## Access Report

### UTS Central Project, 1-73 Broadway, Ultimo

#### Section 4.55 Modification for consent approval No SSD7382

22<sup>nd</sup> October 2018

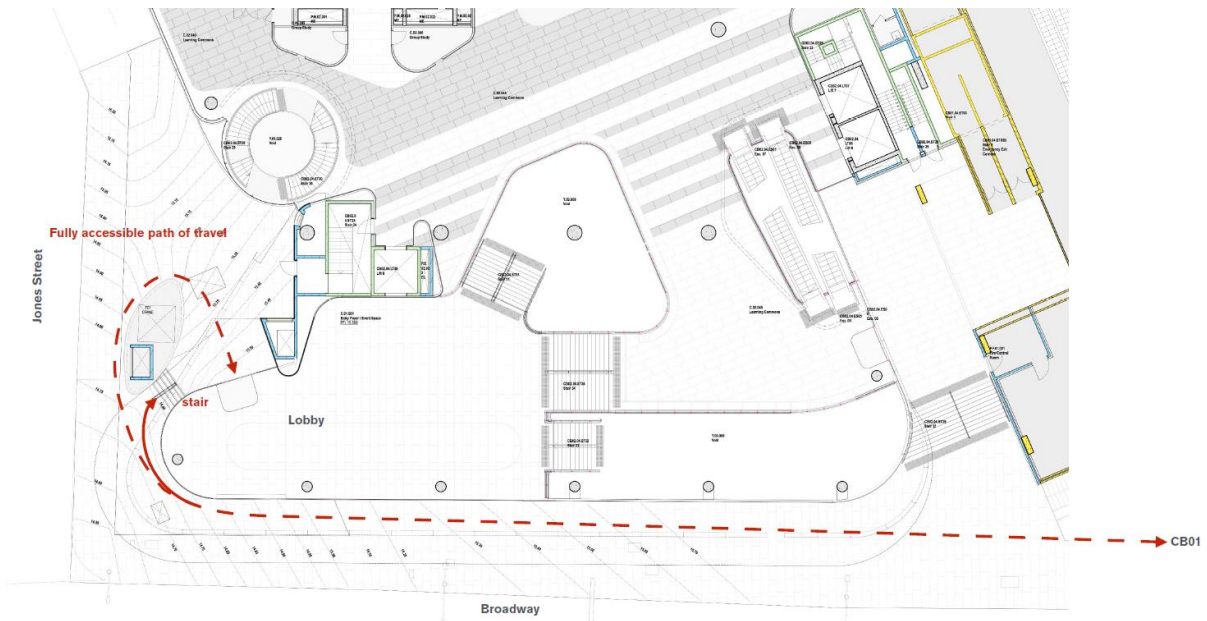
This statement covers the external surrounds of Building 2 adjacent to Jones Street and Broadway as shown below. In particular, the accessibility of the public domain.

- To enable an accessible doorway landing at the lower ground level lobby entrance adjacent to Jones Street and ensure a continuous accessible path of travel to the

entrance it is essential to install a stairway of four risers with handrails and other features in accordance with AS1428.1 and AS1428.4.1.

- In my opinion the proposal provides enhanced accessibility compared to the natural grades at the junction of Jones Street and Broadway.
- In addition to the area adjoining Jones Street and Broadway the proposed paving works will provide appropriate access in accordance with AS1428.1.
